**RE: 225 BUNGARRIBEE ROAD, BLACKTOWN (DA-21-00558)
KRISHATHI PTY LIMITED -V- BLACKTOWN CITY COUNCIL (LEC CASE NO. 2021 / 146814)
LETTER OF RESPONSE TO TRAFFIC CONTENTIONS**

We refer to recent correspondence concerning the abovementioned Court proceedings and the Statement of Facts and Contentions (SOFC) issued by Blacktown City Council (Council) dated 14/07/2021, relating to the deemed refusal of Development Application, DA-21-00558.

Attachment 2

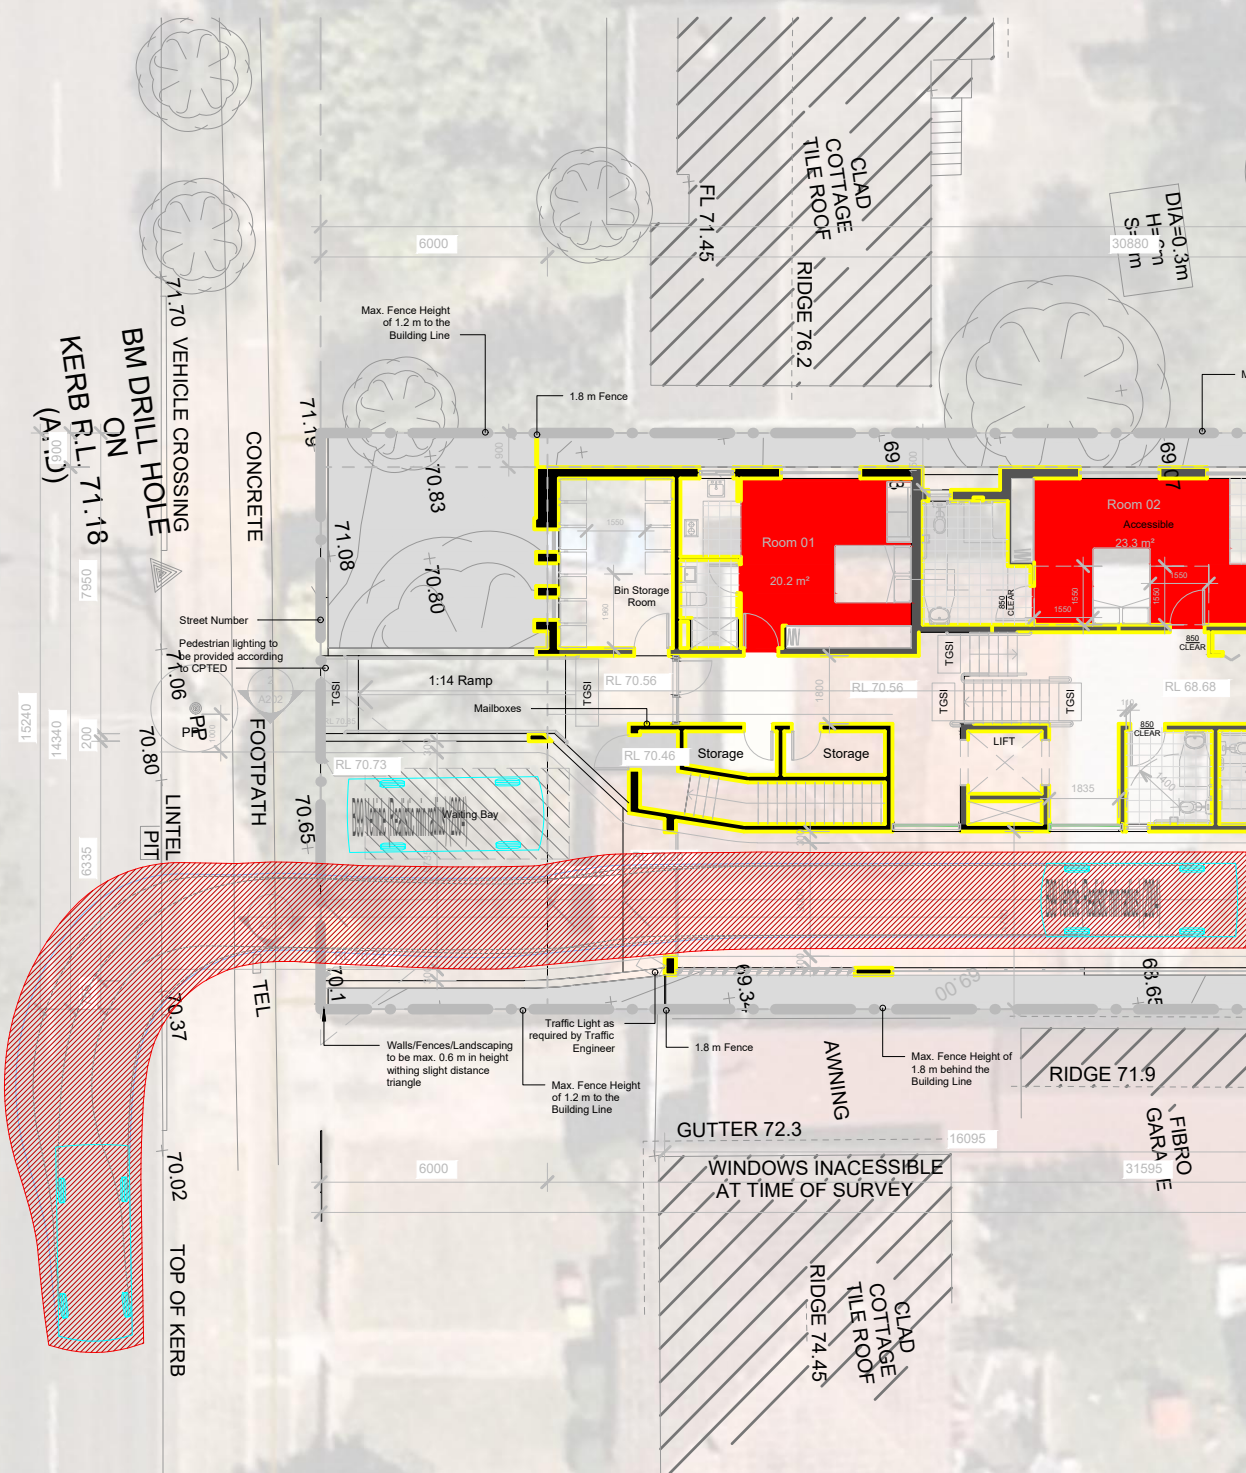
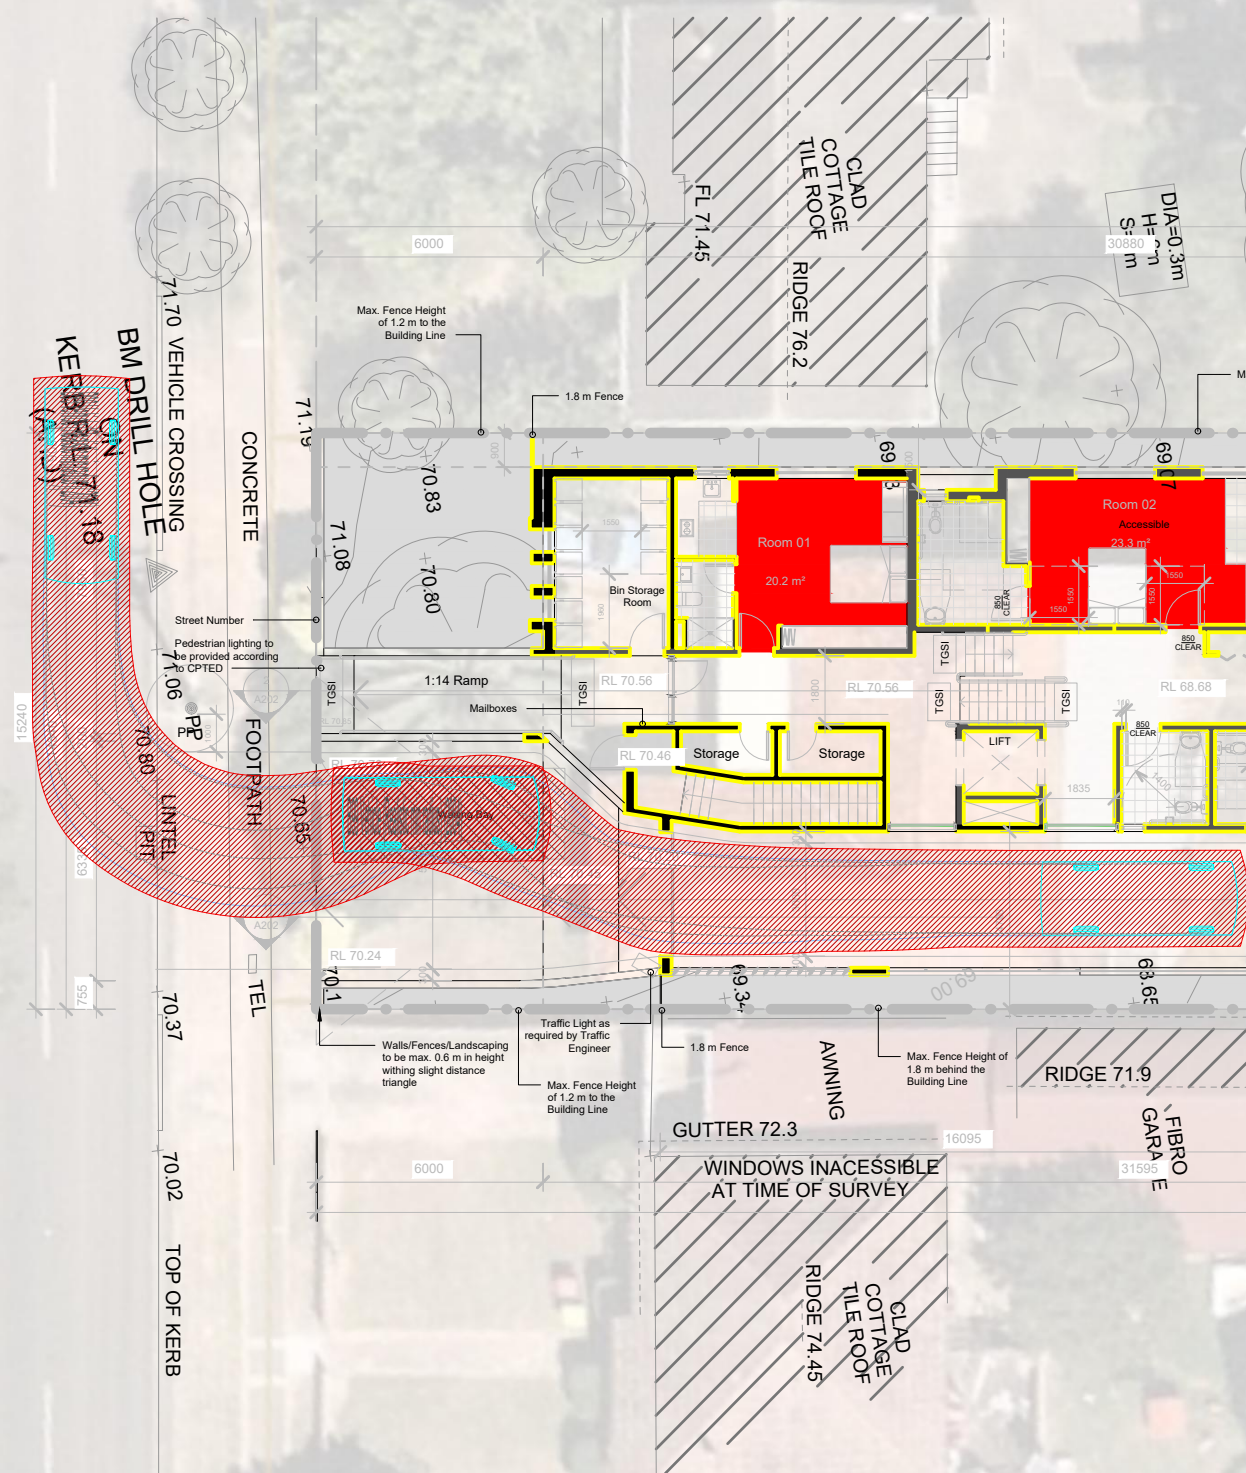
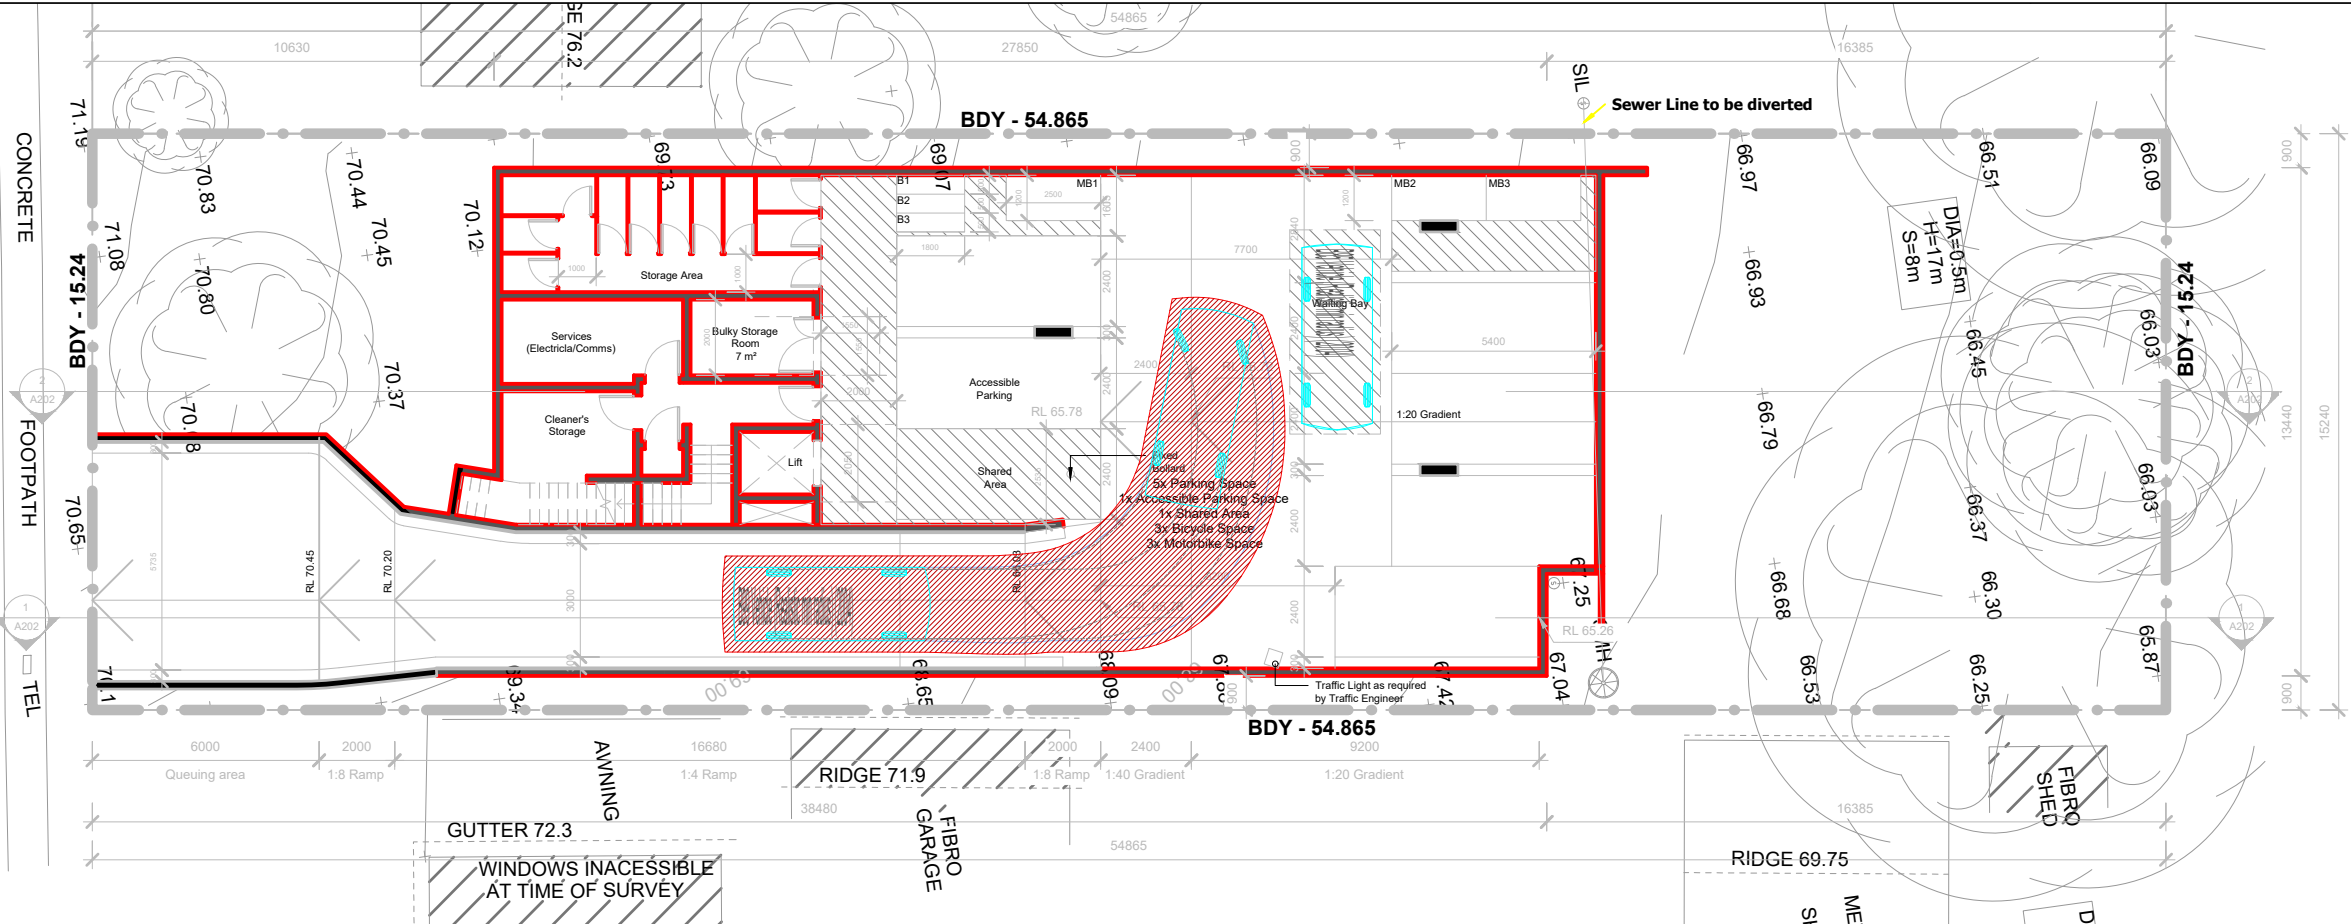
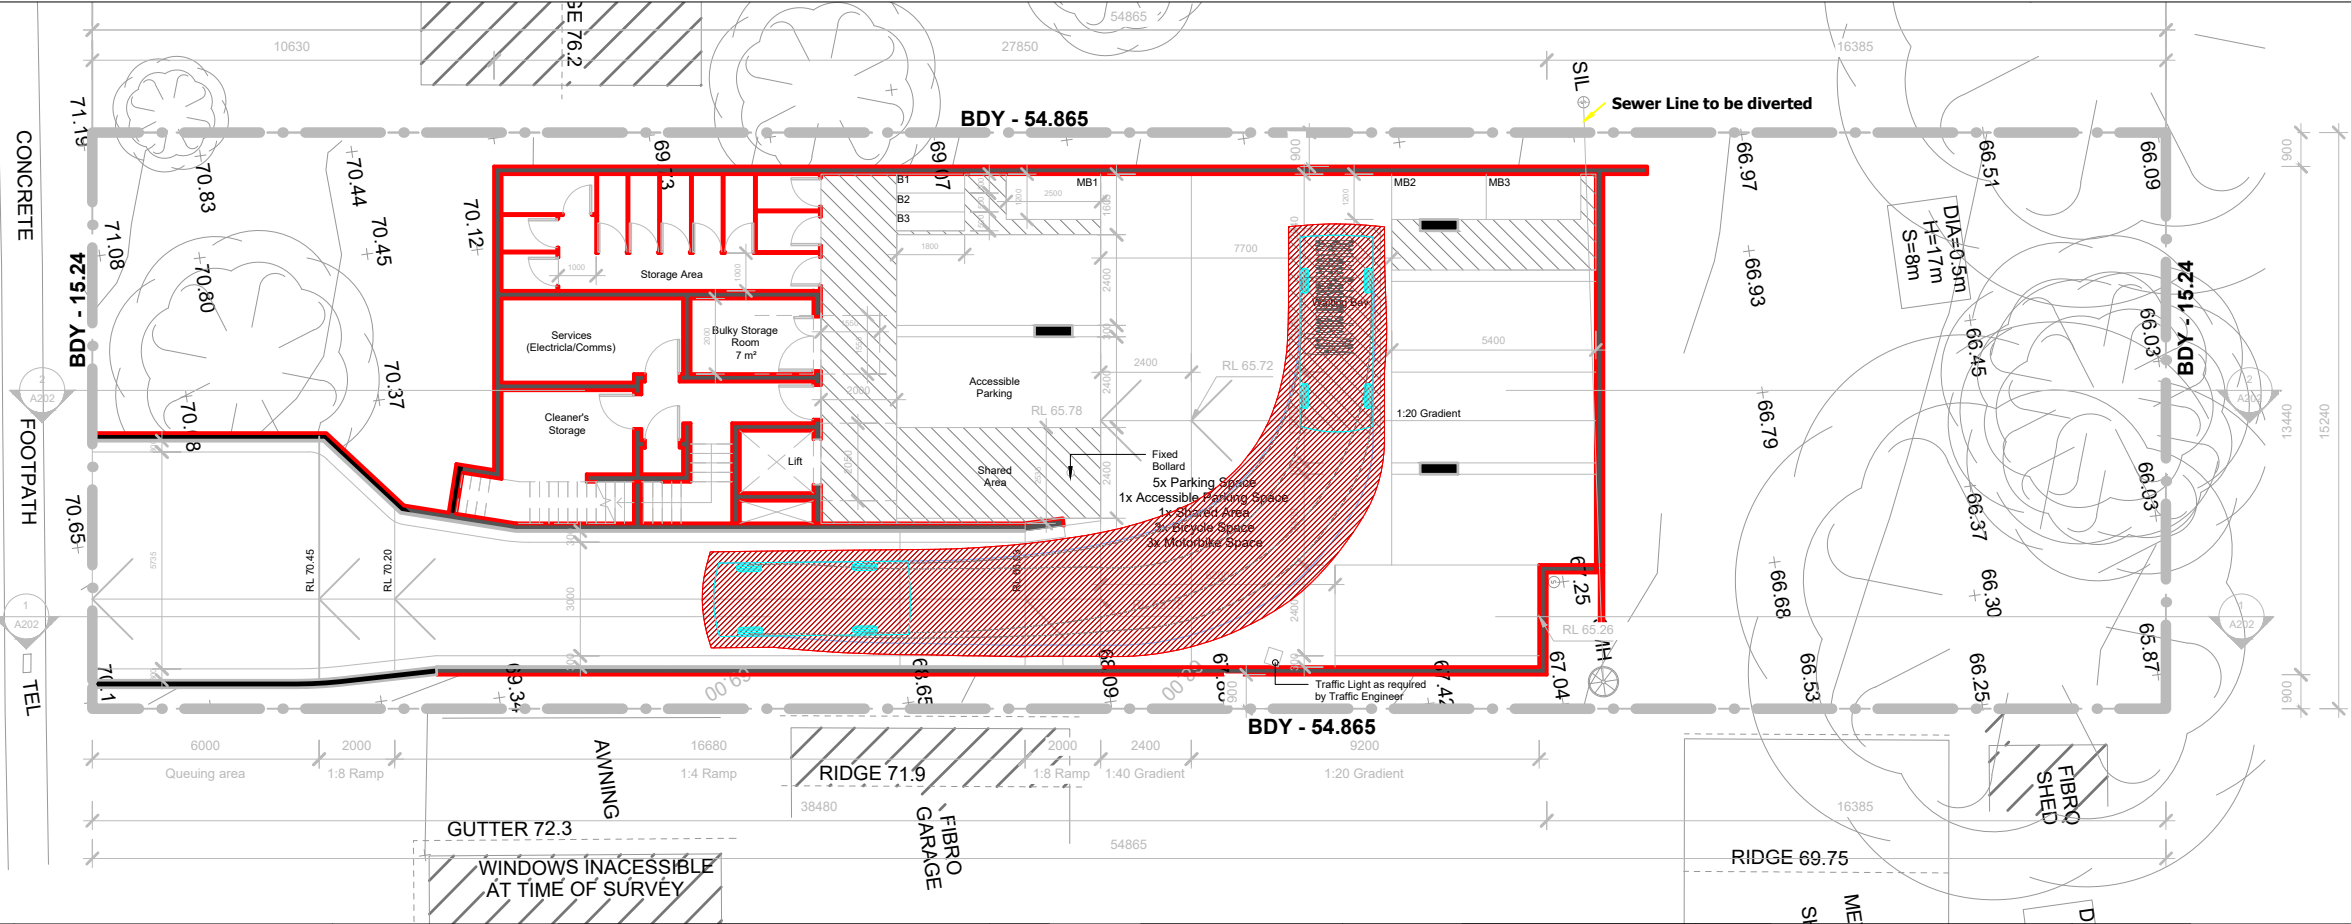
b) Insufficient turning circles have been provided in accordance with Section 2.5.2 of AS2890.1 for passing at the site driveway and within the basement. Turning paths are to be provided for the B99 design vehicle turning left into the site driveway from the public road and passing a B85 design vehicle exiting the site in addition to swept paths for the B99 design vehicle within areas designed for use by one vehicle at a time.

d) Turning circles in the basement are not practical or workable for cars. The results show the required 0.3m vehicle clearance overlapping with high obstructions (walls, columns, motorcycle spaces, kerbs and car parking spaces) which is contrary to the requirements of AS2890.1. It appears 'turn on spot' has been used for swept paths (basement and along the driveway) which is a design flaw not representing realistic vehicle manoeuvres. The dwg files for the swept paths are to be provided.

Updated swept path analysis has been undertaken of the vehicle access with the results provided as **Attachment 2**. The results demonstrate satisfactory turn movements for a:

- B99 Design Vehicle turning left-in and left-out of the access driveway from the public road and passing a B85 Design Vehicle.
- B99 Design Vehicle entering the basement car park and passing a B85 Design Vehicle situated within the waiting bay.
- B99 Design Vehicle exiting the basement car park.
- B85 Design Vehicle entering / exiting all car spaces.

The results demonstrate satisfactory operation of the car park and compliance with Appendix B of AS 2890.1.

As per our respond to Contention 6(b), updated swept path analysis has been undertaken of the basement, including for entry / exit to all car spaces with the results provided in **Attachment 2**.

The 'turn from stop' function has only been used where a vehicle has changed from a forward-movement to a reverse-movement or from a reverse-movement to a forward-movement as is standard practice in the traffic engineering profession. The updated swept path results also show that 0.3m clearances are now clear of all vehicle obstructions including walls, columns, motorcycle spaces, kerbs and car parking spaces.
